INITIAL FIRE SAFETY INSPECTION REPORT

Gumti Textile Ltd. (Extension)

RSC ID: 25892

Date: 21 August, 2025

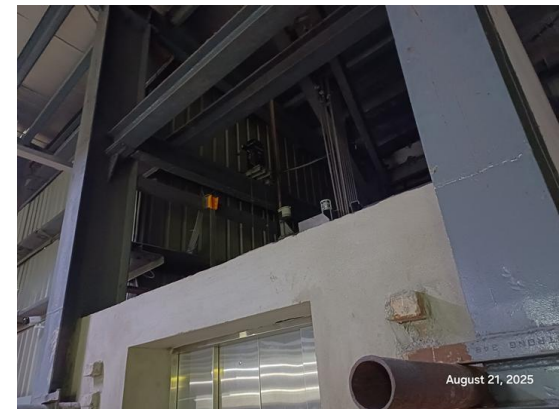
SI No.	Category	Findings	Required Action	Remediation Time Frame
F5	Fire Rated Construction	<p>N-W Elevator shaft open directly into the N-W exit enclosure-3, which doesn't comply with RSC Technical Guidelines (Standard) , section 6.14.3.</p> <p>Mid- East Elevator shaft open directly into the production floor without proper fire separation due to unprotected barrier and opening.</p> <p>Location: Building-D.</p> <p>Non-Compliance Reason: (i) Unprotected steel structural element; (ii) Unprotected opening & (iii) Partition wall was not constructed on the upper machine room portion.</p>	<p>Provide a minimum 2-hr fire rated elevator shaft to separate it from stair enclosure. No discharge is accepted through elevator shaft. Seal all openings to maintain fire separations.</p> <p>Elevator shaft shall be separated from production area by 2 hours fire rated construction. 2-hr fire barriers shall be protected with minimum 1.5-hr fire protective opening assemblies.</p>	Within 3 Months

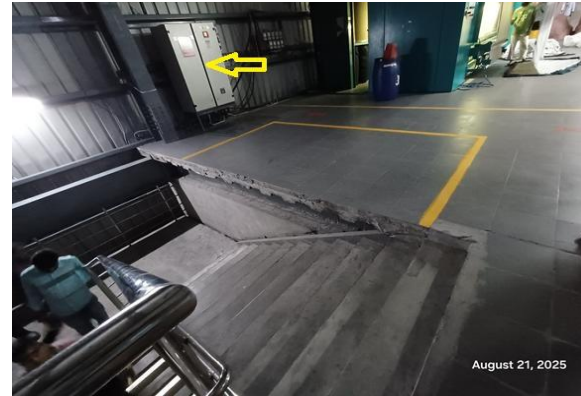
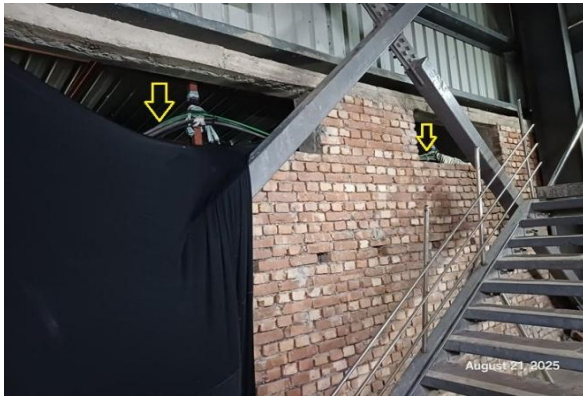
SI No.	Category	Findings	Required Action	Remediation Time Frame
F6	Means of Egress	<p>Unsealed penetrations and openings are located in exit stair enclosures.</p> <p>Electrical cable raceway passing through the exit enclosure on ground floor south-east staircase-1. Electrical DB located on 1st floor of N-W staircase-3.</p>	<p>No other penetration into and through the exit enclosure except for fire alarm equipment electrical raceway, required exit doors, sprinkler piping, standpipes, and electrical conduit serving the exit enclosure is permitted in accordance with section 6.14.4 of RSC Technical Guidelines (Standard)¹ V1.0. So, relocate the electrical wires/raceways to somewhere else avoiding the exit enclosure, and seal the created unprotected openings with a minimum of 1.5 hours listed/certified fire-rated materials. Installation shall be as per manufacturer published installation guideline and the certification authority guideline to ensure the fire-rating. Or seal the penetration by 2-hr masonry construction.</p>	Within 3 Months

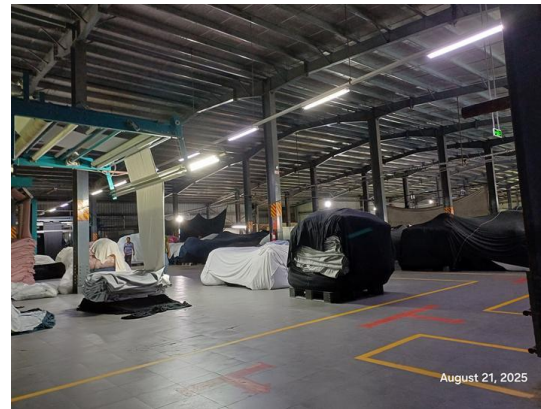
SI No.	Category	Findings	Required Action	Remediation Time Frame
F7	Fire Rated Construction	<p>Rooms used for storage of combustible materials is not separated from the surrounding occupancy.</p> <p>Location: Finished goods store on 1st floor with dyeing finishing section in Building-D.</p> <p>Non-Compliance Reason: (i) Fire rated partition wall is not constructed and (ii) Unprotected opening.</p>	<p>Rooms used for storage of combustible materials shall be separated from the surrounding occupancy with a minimum 1 hour construction in accordance with section 3.4.2.1.5 of RSC Technical Guideline (Standard).</p>	Within 3 Months

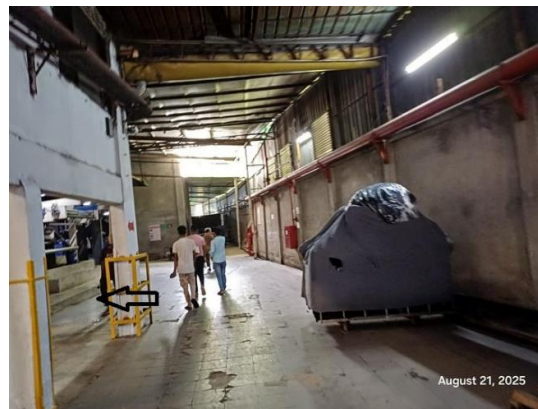
SI No.	Category	Findings	Required Action	Remediation Time Frame
F10	Means of Egress	The egress court serving south-west exit is not open to the sky or provided with a fire resistance rated enclosure the same as the exit enclosure as there are non-rated openings from adjacent buildings exterior (Building-A, E, Shed-C and Utility Building) which is not in accordance with section 6.17.2 or 6.17.3 of RSC Technical Guidelines (Standard) ¹ V1.0.	Exits shall discharge directly to the exterior of the building unless meeting the requirements of 6.17.2 or 6.17.3 as per RSC Technical Guidelines (Standard) ¹ V1.0.	Within 3 Months

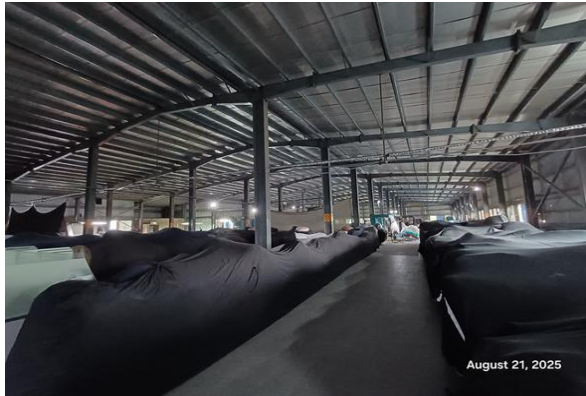
SI No.	Category	Findings	Required Action	Remediation Time Frame
F11	Means of Egress	<p>Aisles were found missing on several locations throughout the building.</p> <p>Location: 1st Floor of Building-D, Ground floor of fabrics relaxation shed-2 and shed-3.</p>	<p>Provide minimum aisle widths of 36-in. Aisles mark shall be clearly visible.</p>	<p>Within 1 Month</p>

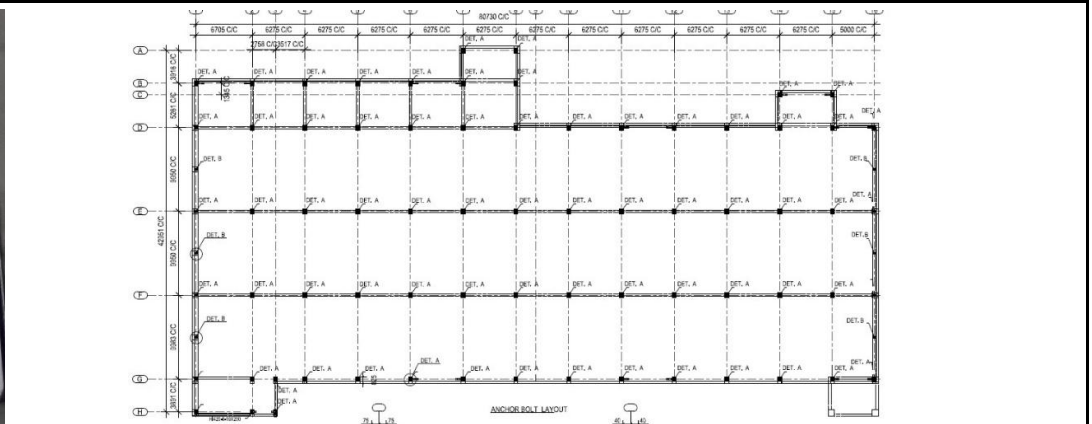
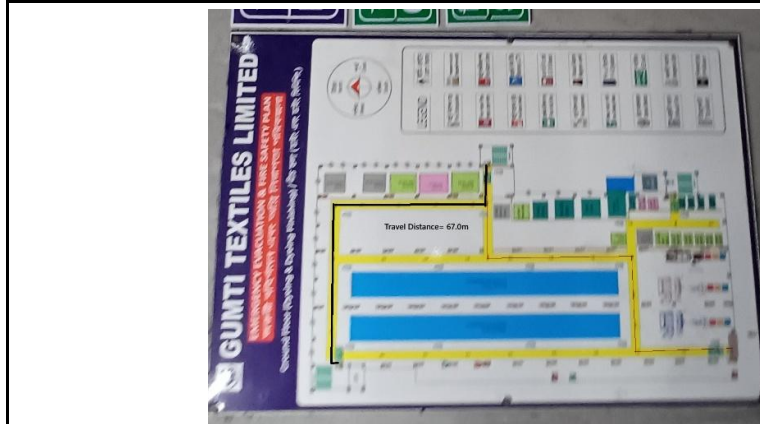
SI No.	Category	Findings	Required Action	Remediation Time Frame
F12	Means of Egress	<p>The maximum travel distance exceeds 60 m which does not meet the requirements of Section 6.13 of RSC Technical Guidelines (Standard).</p> <p>Location: Ground Floor and 1st floor of Building-D, Ground floor fabrics relaxation shed-2 and shed-3.</p> <p>Occupancy: G2 & H2.</p> <p>Available travel distance: 67.0m on ground floor.</p>	<p>Reconfigure the egress arrangement to meet 6.13 of RSC Technical Guidelines (Standard).</p> <p>Or,</p> <p>Provide additional exits so that the travel distance shall not exceed the maximum allowable limit.</p>	Within 3 Months

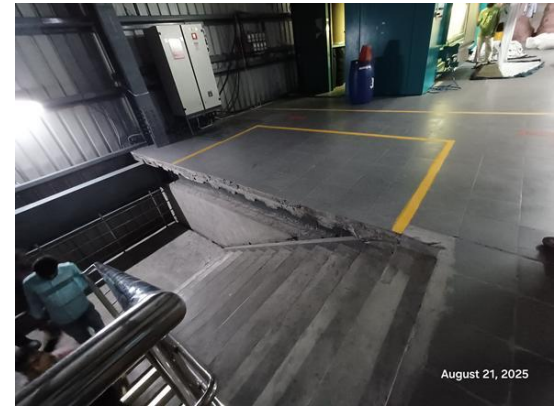
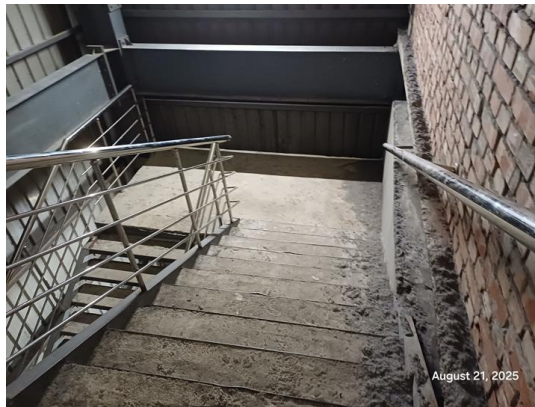
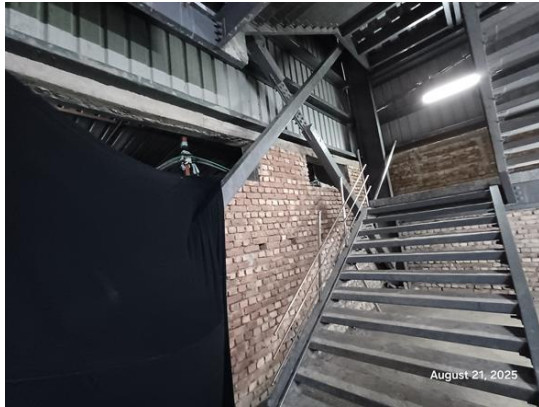
SI No.	Category	Findings	Required Action	Remediation Time Frame
F13	Means of Egress	<p>Stair clear width was found less than 60 in.</p> <p>Location: South-east Stair-1, Mid-east Stair -2 and North west stair-3.</p> <p>Available Stair Width: 4'-7", 4'-9" and 4'-8".</p>	<p>Stairs shall have a minimum clear width of 60 in. in for all industrial occupancies as per RSC Technical Guideline (Standard) section of 6.5.6.</p>	<p>Within 3 Months</p>

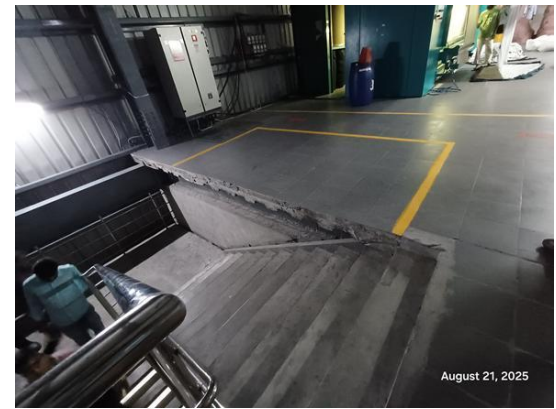
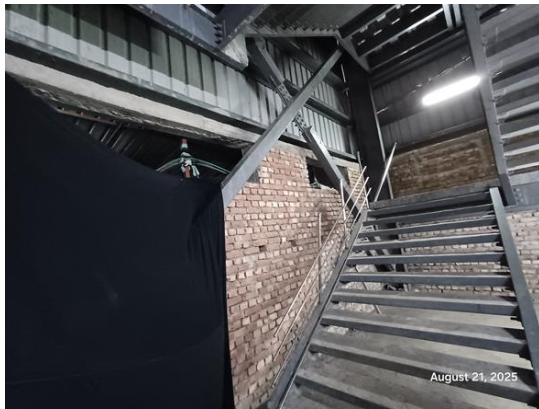
SI No.	Category	Findings	Required Action	Remediation Time Frame
F14	Means of Egress	<p>Handrails are not provided on both sides of each exit stairs on all floors. Having handrails on one side of said staircase, may pose as a falling hazard during evacuation.</p> <p>Location: South-east Stair-1 and North west stair-3.</p>	<p>Provide handrails on both sides of the exit stair. New handrails shall have a minimum height of 865 mm (34 in.) and a maximum height of 965 mm (38 in.) as measured from the leading edge of the tread. Intermediate handrails shall be provided when the stair width exceeds 2.2 m (87 in.).</p> <p>Open guards shall have intermediate rails or pattern such that a sphere 200 mm (8 in.) in diameter cannot pass through any opening up to a height of 865 mm (34 in.). Handrail shall construct in accordance with RSC Technical Guidelines (Standard)¹ V1.0 Section 6.12.</p>	Within 3 Months

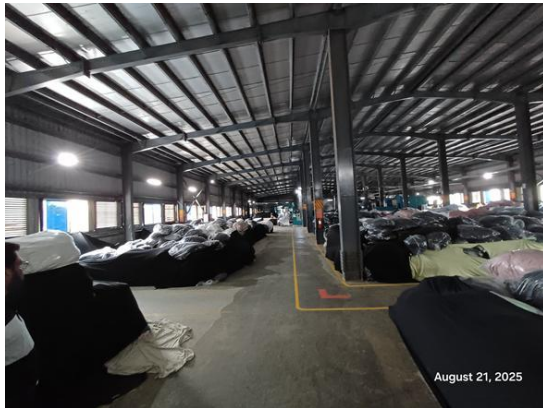
SI No.	Category	Findings	Required Action	Remediation Time Frame
F15	Fire Alarm & Detection System (FADS)	1. Building-D: Production Building (2 storied steel building), 2. Single storied Shed-2; 3. Single Storied Shed-3; 4. Single storied toilet zone; 5. Single storied Compressor Room; 6. Single storied SDB Room are not provided with centralized addressable listed fire alarm and detection system.	Submit the proposed fire alarm system design to RSC for review. Once the design is reviewed, install/modify the fire detection and alarm system throughout the building in accordance with review comment, RSC/ RSC Technical Guidelines (Standard) and NFPA 72. After installation the owner shall conduct internal testing and commissioning and then contact the RSC for witness of final acceptance testing.	Design within 2 Months and modification/ installation with 4 Months

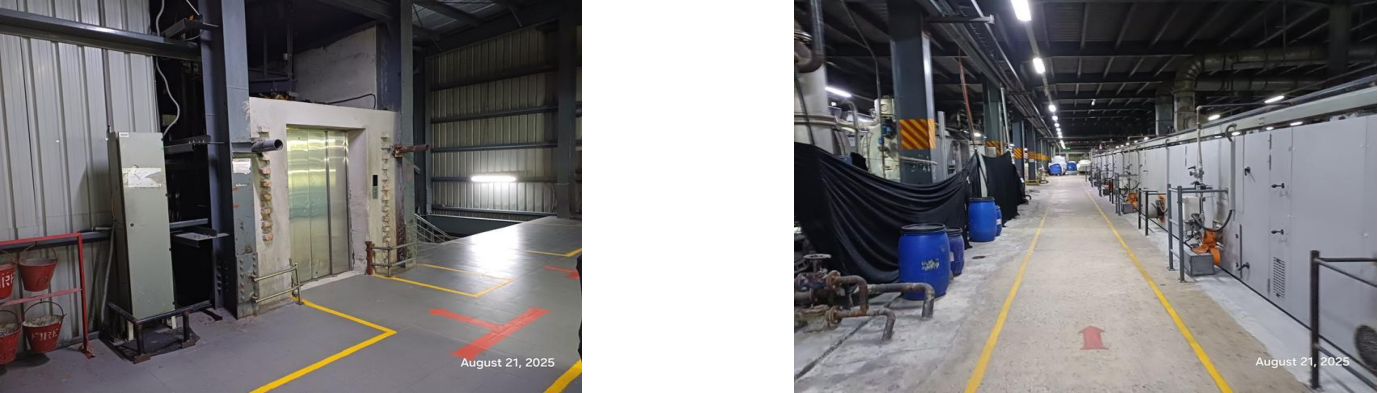
SI No.	Category	Findings	Required Action	Remediation Time Frame
F18	Means of Egress (Egress Lighting)	<p>Based on the number and location of emergency lights observed, adequate illumination levels are not anticipated along egress routes.</p> <p>Location: Both floors of Building-D; Fabric relaxation Shed-2; Fabric Relaxation Shed-3; Toilet Rooms; Compressor Room; & SDB Room.</p>	<p>Test the emergency lighting system on each floor and provide additional emergency fixtures to provide adequate illumination along the means of egress. Provide a minimum illumination of 10 lux at the floor level within exit stairs and exit discharge paths and minimum 2.5 lux along exit access aisles. Illumination on means of egress shall meet in accordance with RSC Technical Guidelines (Standard)¹ V1.0 Section 10.12.2.</p>	Within 3 Months

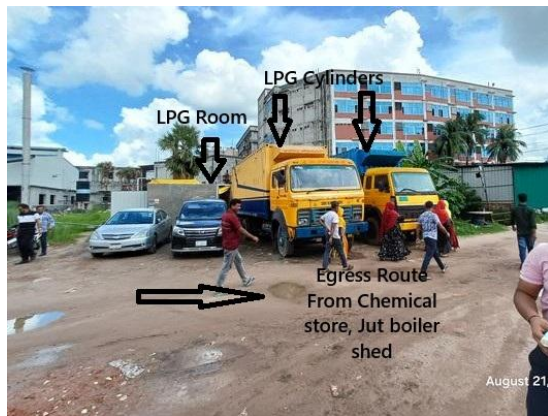
SI No.	Category	Findings	Required Action	Remediation Time Frame
F26	Fire Rated Construction	Liquefied or compressed gas cylinders were located within the factory premises on ground floor with vaporizer room and RCU and egress route from chemical shed and Jhut boiler Shed without adequate fire separation.	Factory shall follow the requirements RSC Published "SUPPLEMENTARY PAPER ON TECHNICAL GUIDANCE NOTE FOR USE OF LIQUIFIED OR COMPRESSED FLAMMABLE GAS IN FACTORY PREMISES" to use or store liquefied or compressed flammable gas cylinders in the factory premises.	Within 3 Months
